**TOWN GRAY**  
**PLANNING BOARD**  
**AGENDA • JUNE 10, 2021**

**Planning Board  
Regular Meeting**

**TOWN OF GRAY, MAINE  
MAJOR SUBDIVISION APPLICATION  
COMMENT RESPONSE LETTER**

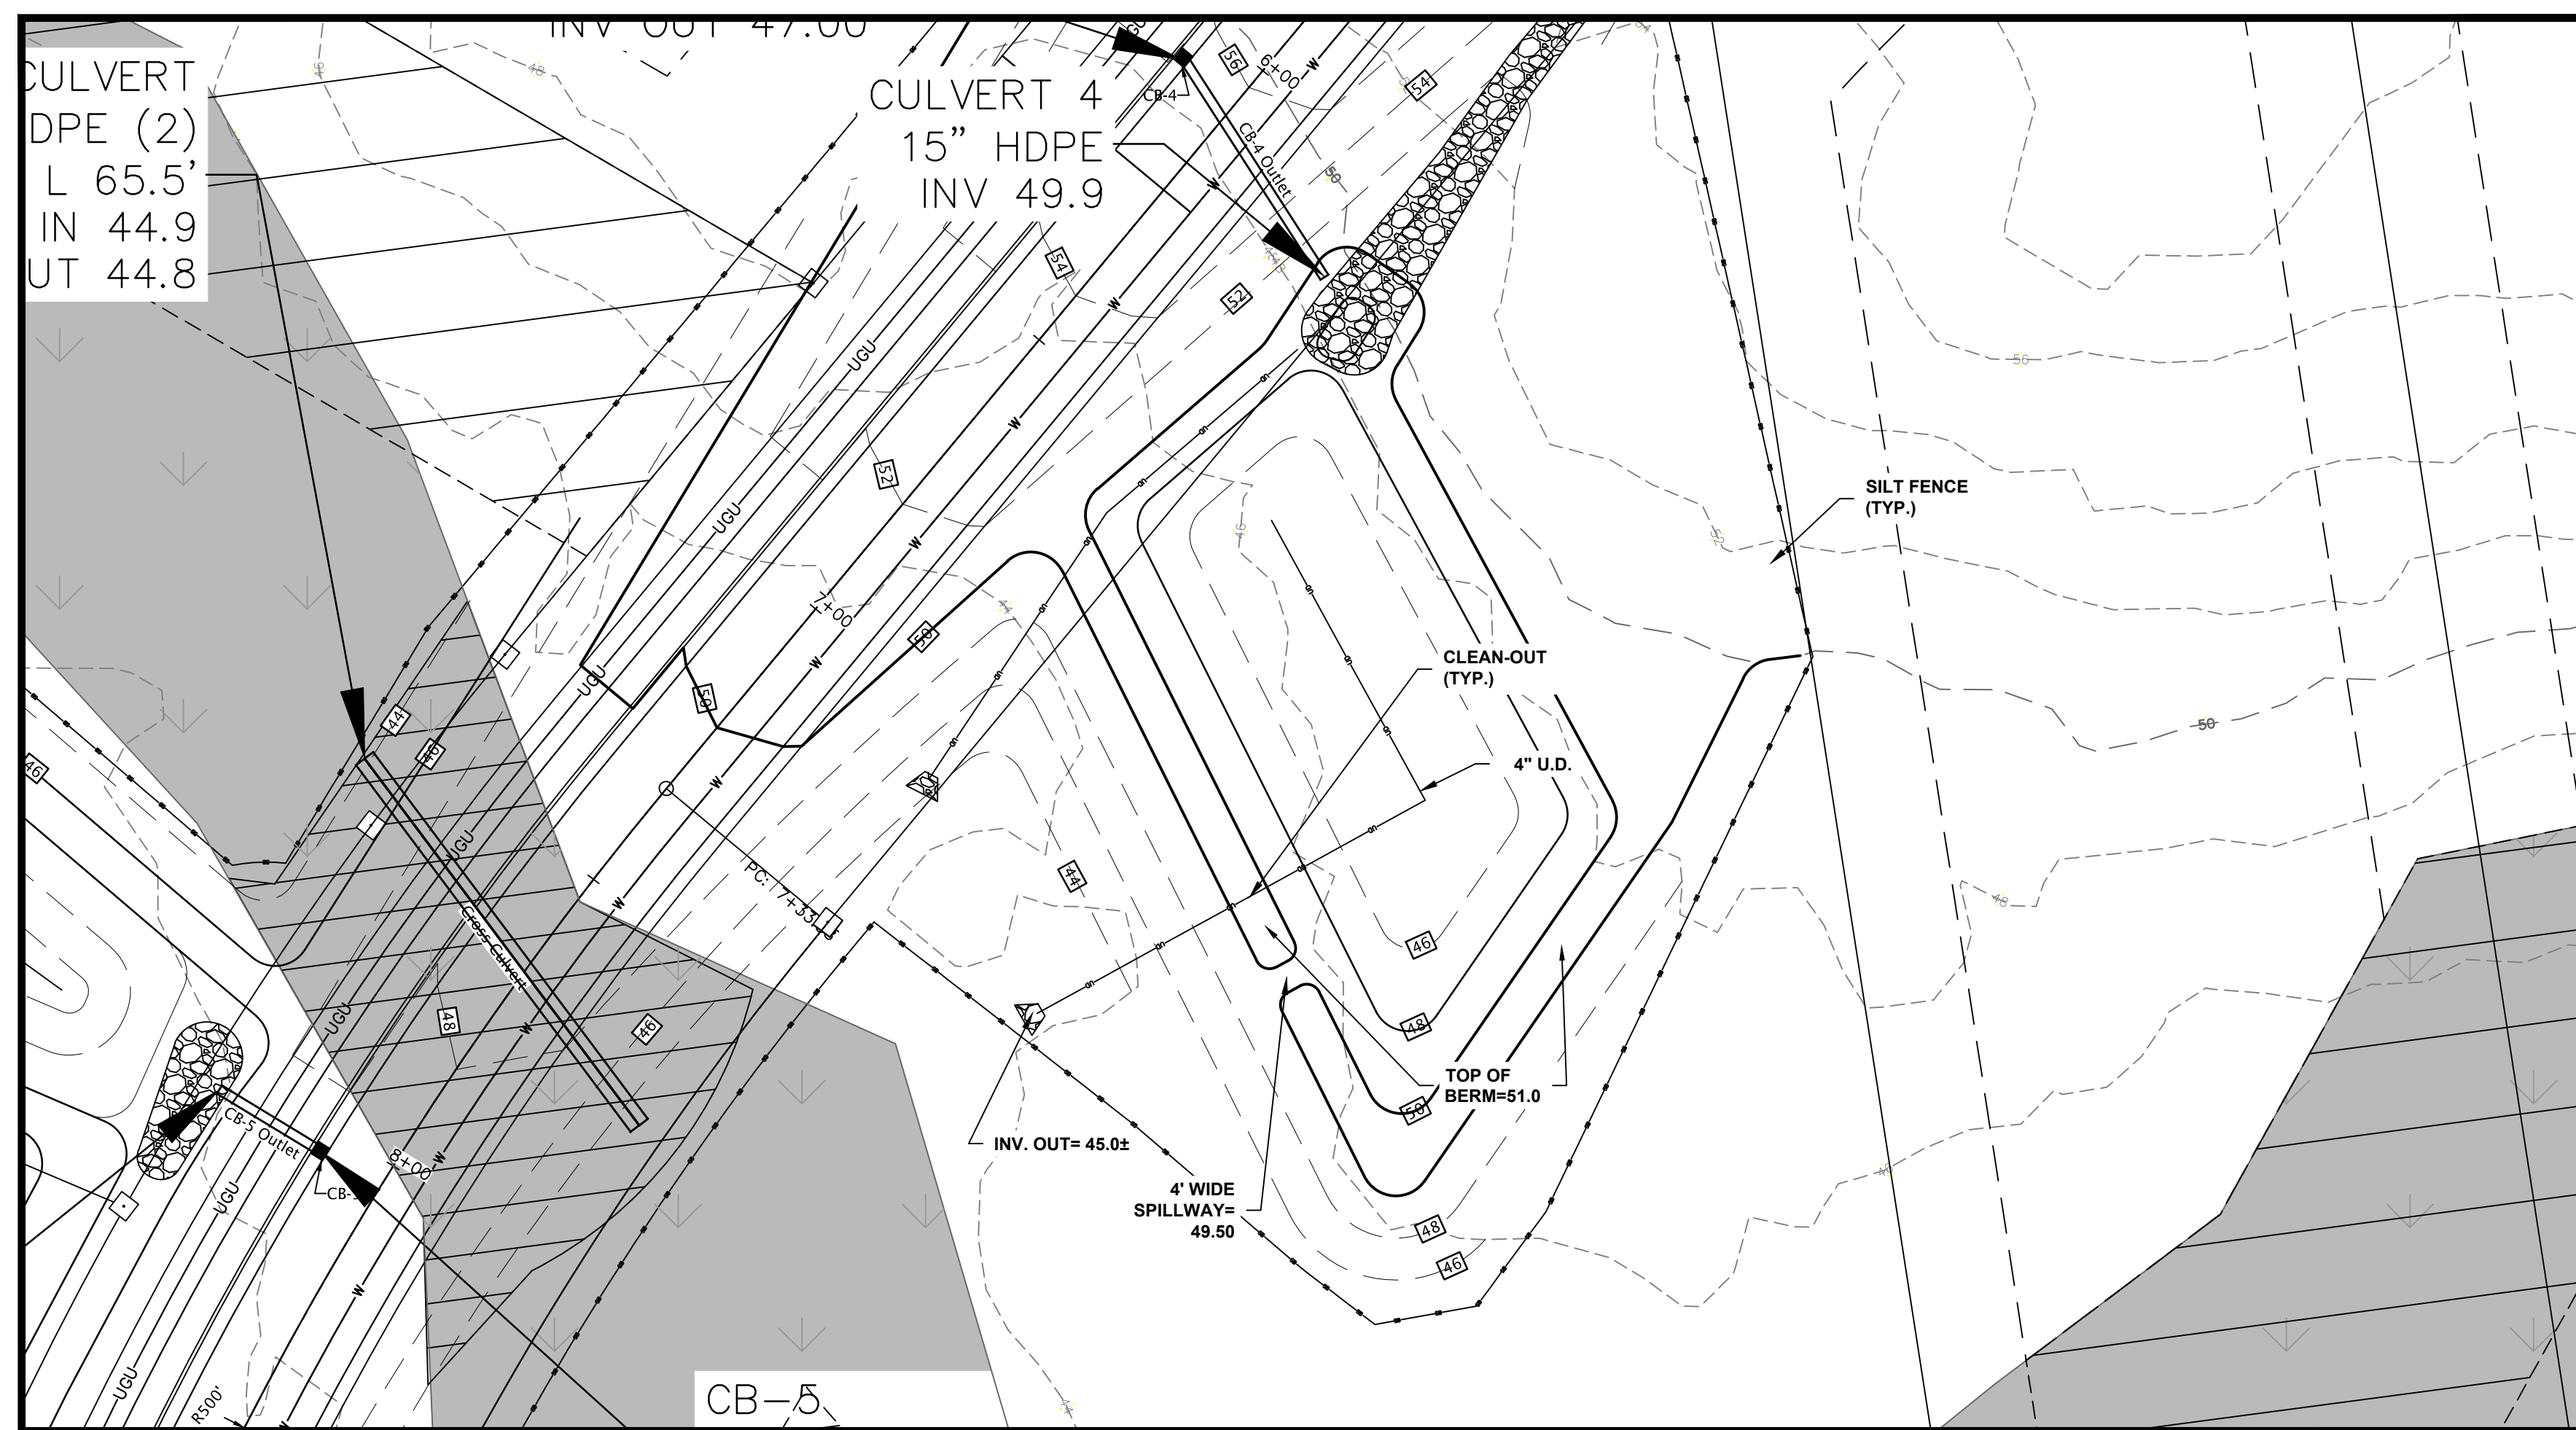
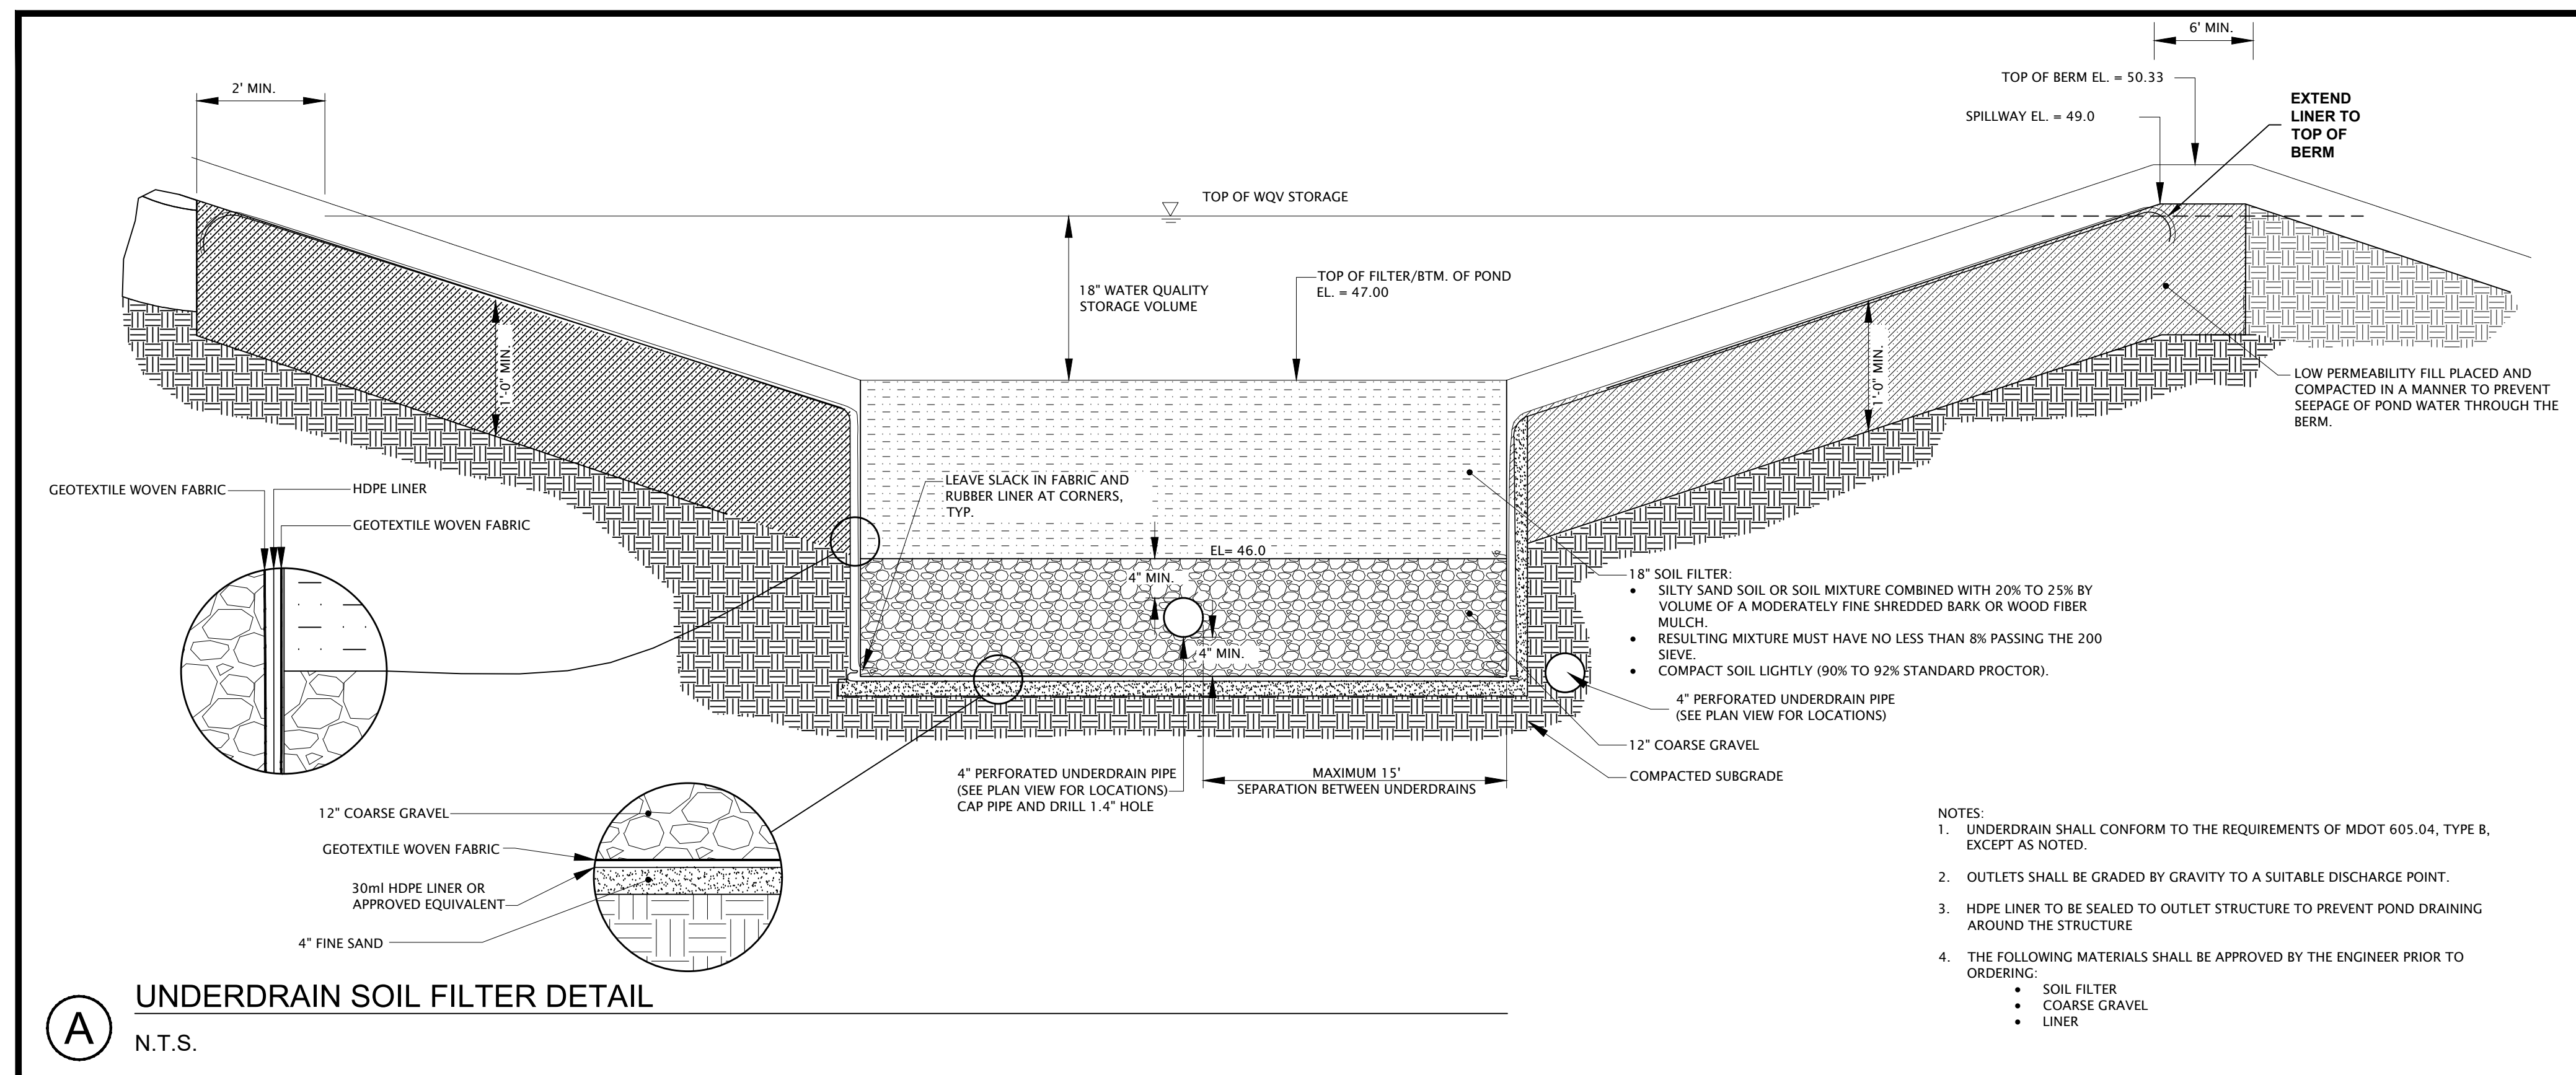
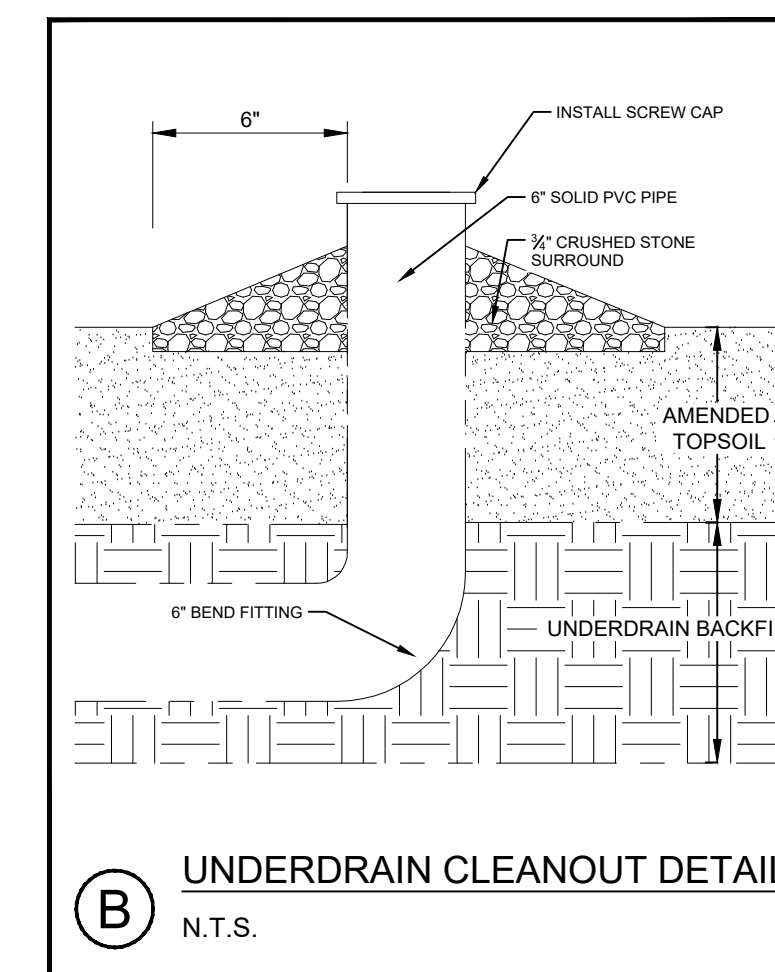
14. Although note 2 of the Bioretention and Underdrained Filter Notes on sheet C304 has been revised to call out a 30 mil liner, the model designation of the liner still lists a 24 mil liner. Revise the model designation from BTL-24 to BTL-30.

DRAWN: MPV/CGB	DATE: JUNE 2021
DESIGNED: CEB/MPV	SCALE: AS SHOWN
CHECKED: JAV/CGB	JOB NO. 20-012
FILE NAME:	
SHEET: C-305

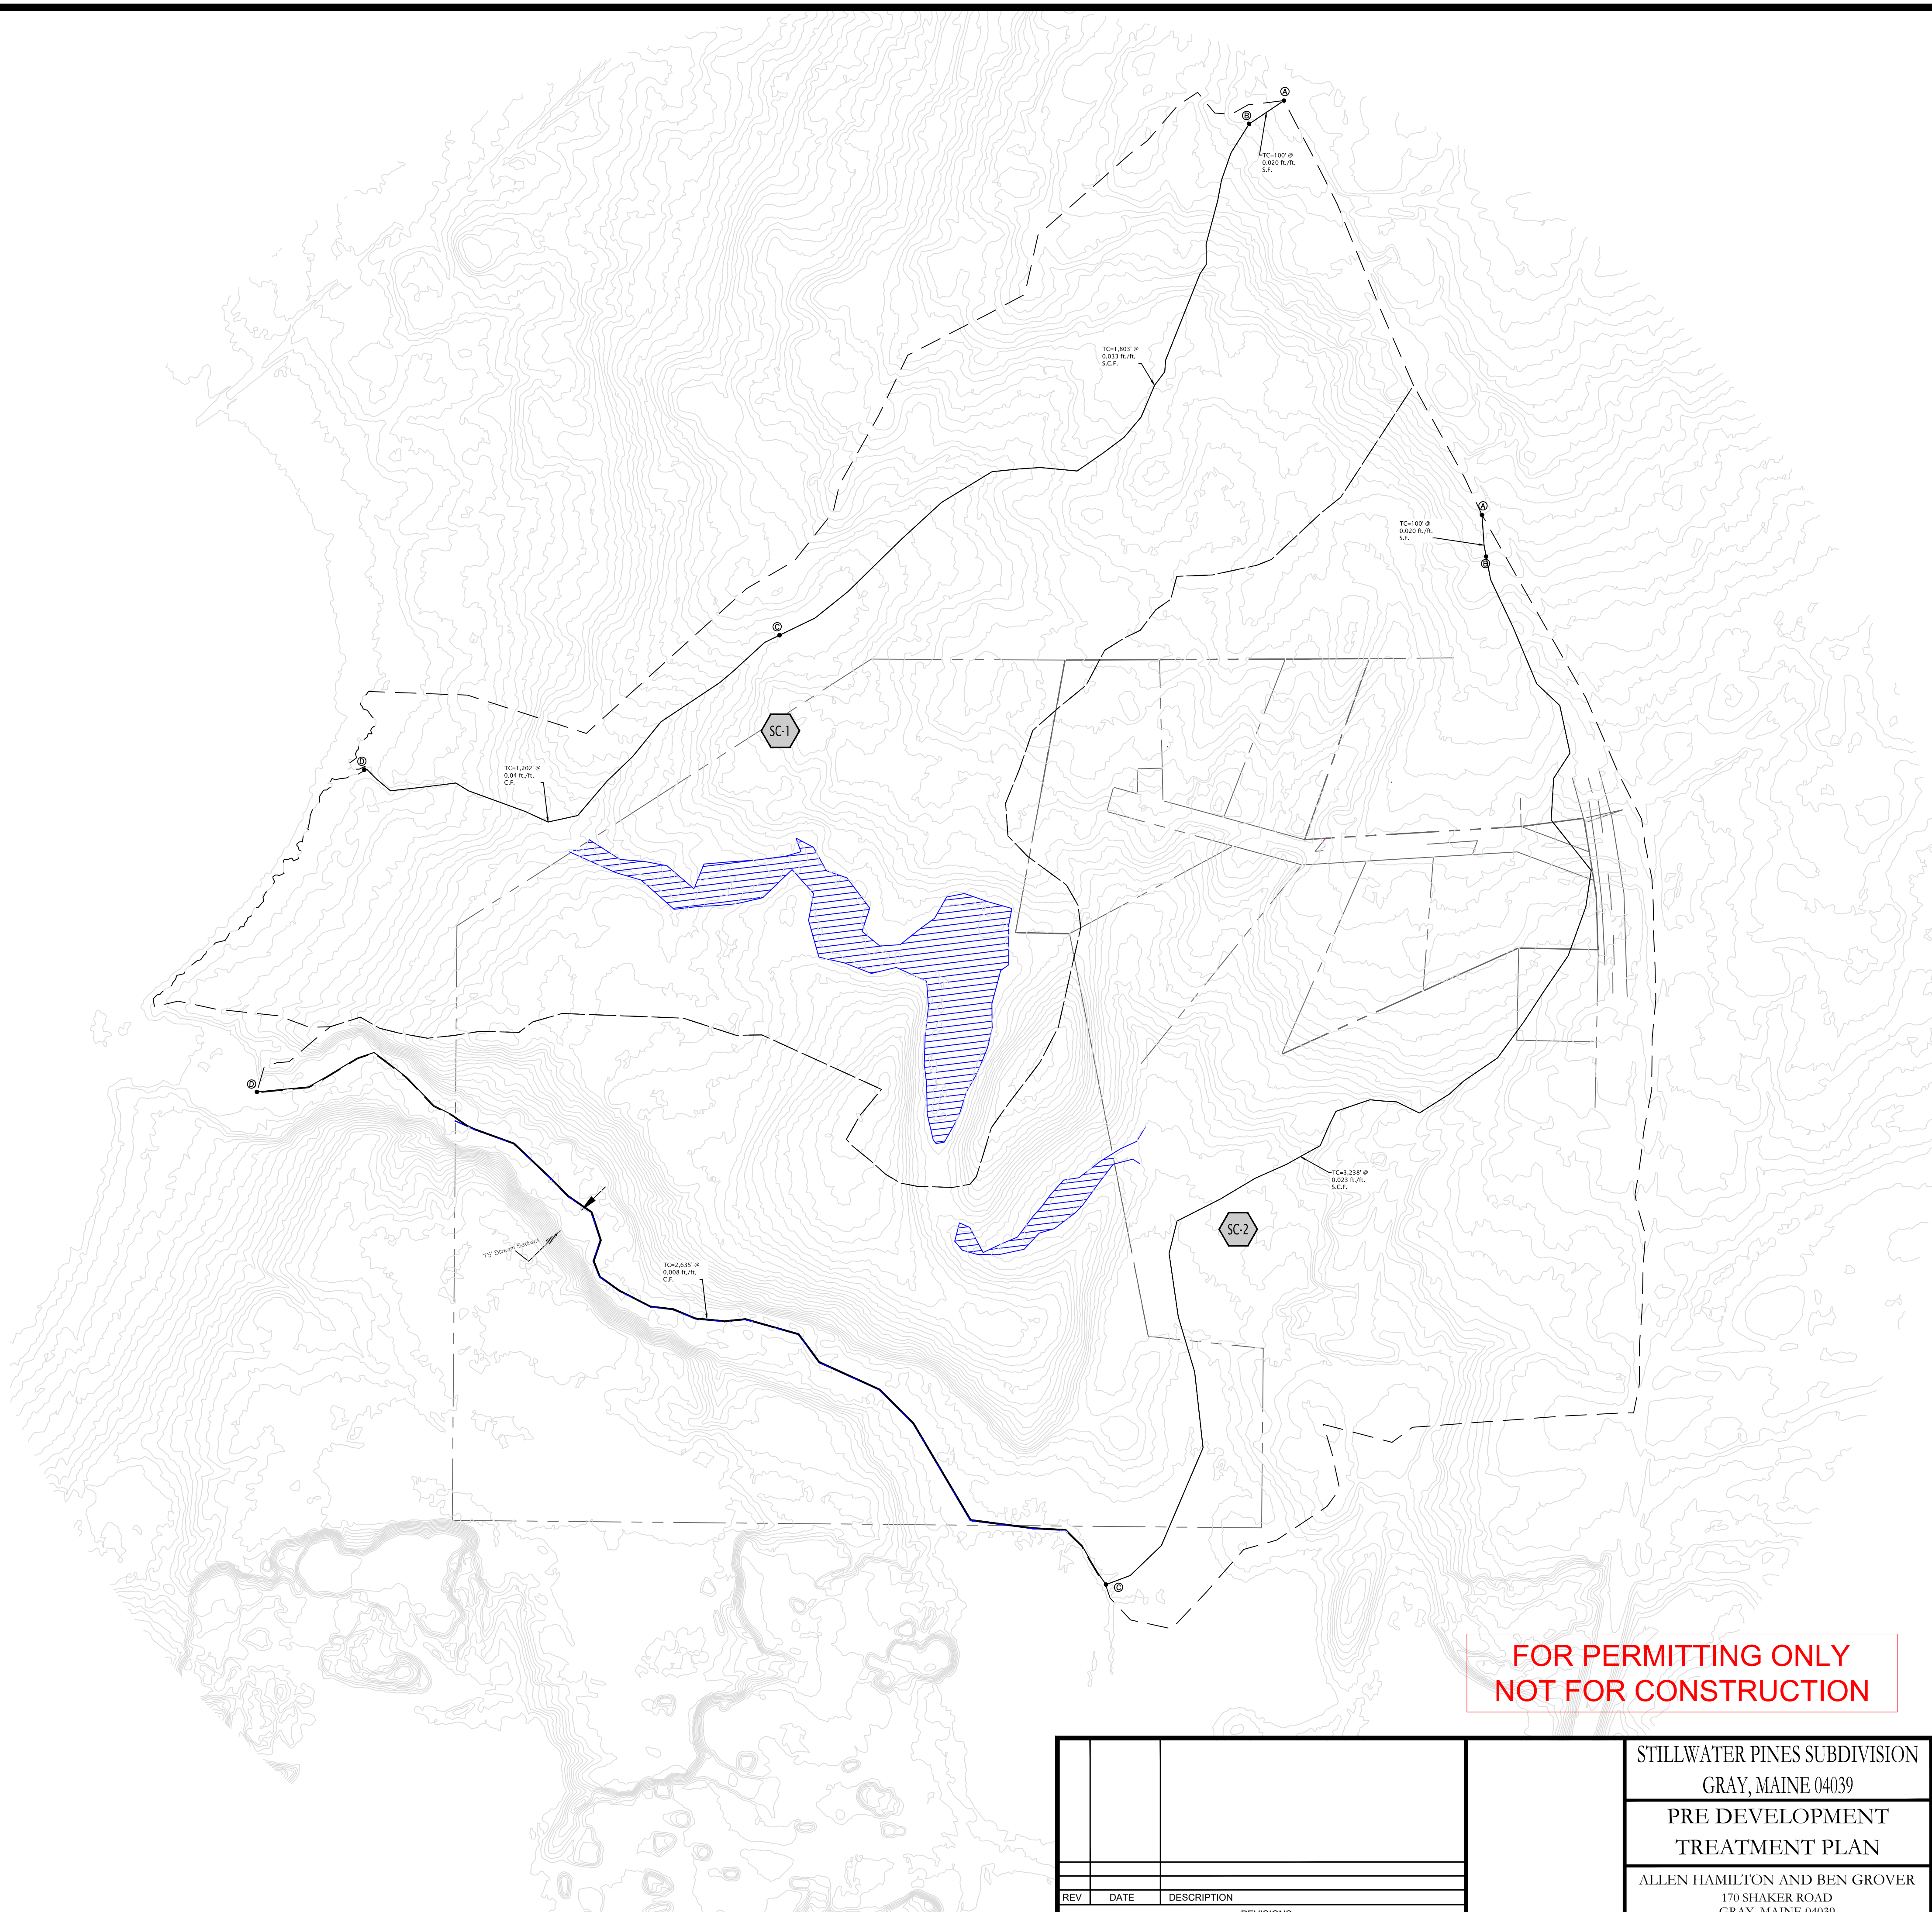
15. The Bioretention and Underdrained Filter Notes, Note 2 on Sheet C305 needs to be revised to call out a 30 mil liner and the model designation needs to be revised to BTL-30.
